TELEDYNE CONTINENTAL ® AIRCRAFT ENGINE
SERVICE BULLETIN

SB11-3

SUBJECT: Alternator and Drive Coupling Installation

PURPOSE: Provides information regarding alternator elastomer coupling and proper installation

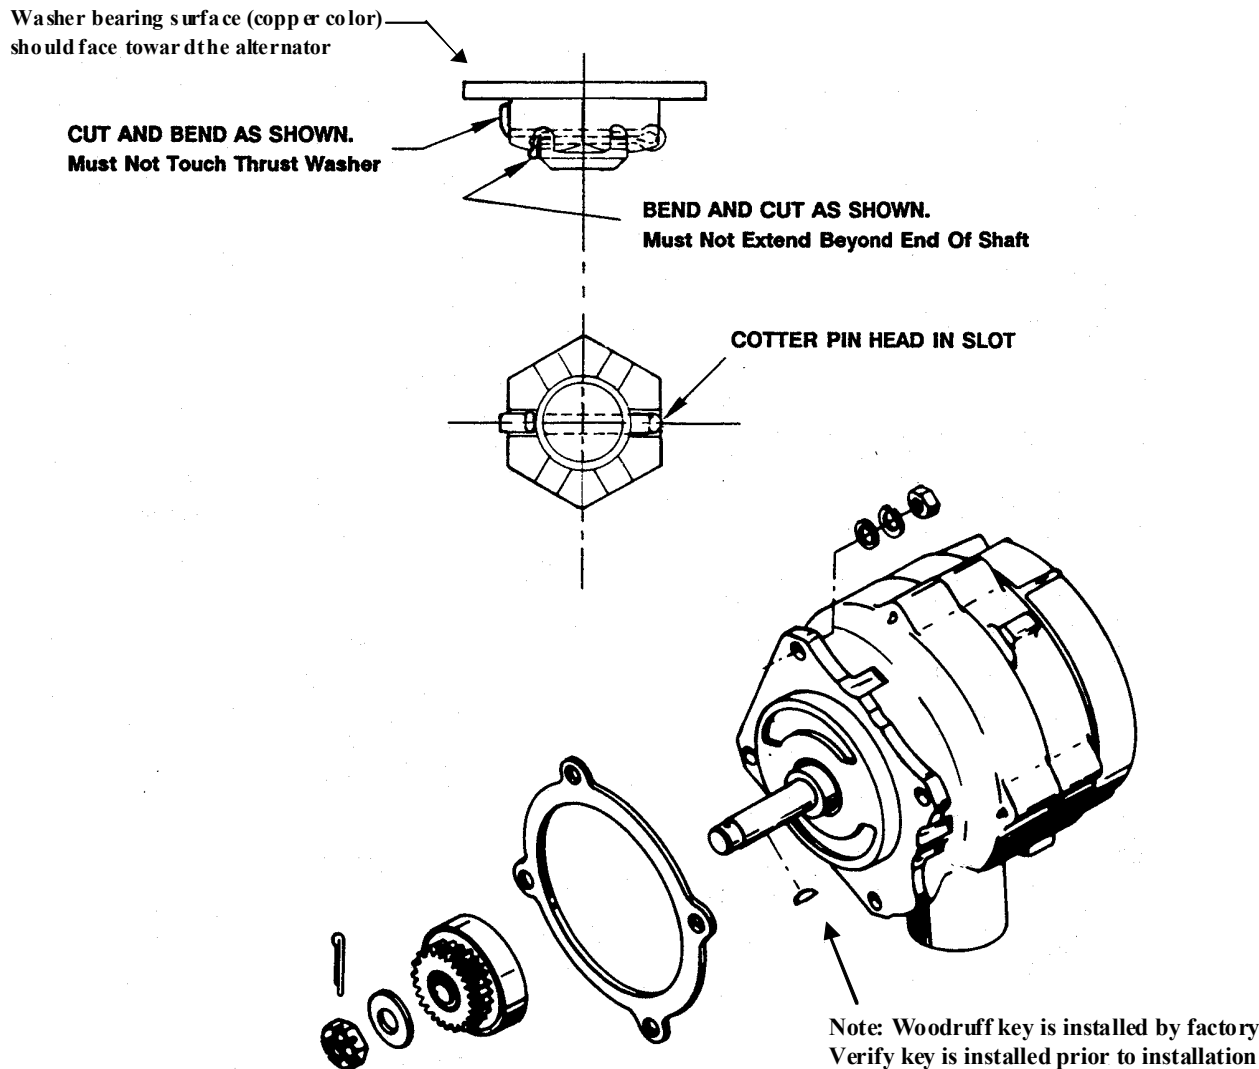
The gear driven alternators used on some of the affected engine models are equipped with a drive coupling P/N 646655 which has an elastomer section to help absorb torsional vibrations and provide a "shear" section. Earlier couplings equipped with a drive spring assembly are superseded with 646655 elastomer couplings. The spring couplings, 640933 and 640934 must be replaced with the 646655 elastomer couplings the next time that maintenance affords access to the coupling.

1. Remove shipping spacer and washer from the alternator shaft and discard

Installation of the drive coupling assembly on alternators with the shipping washer in place will cause interference with the face gear on the crankshaft and will result in damage to the engine and alternator.

2. Install coupling assembly and washer. The washer is a special thrust washer and must be installed with the bearing surface (copper color) toward the alternator. Install nut and tighten to 300 in. lbs. torque. If slots in the nut do not align with the cotter pin hold in alternator shaft, the nut may be tightened further but not to exceed 450 in. lbs.
3. Do not back off nut to align holes. Install cotter pin as shown to insure clearance when alternator is installed in engine.
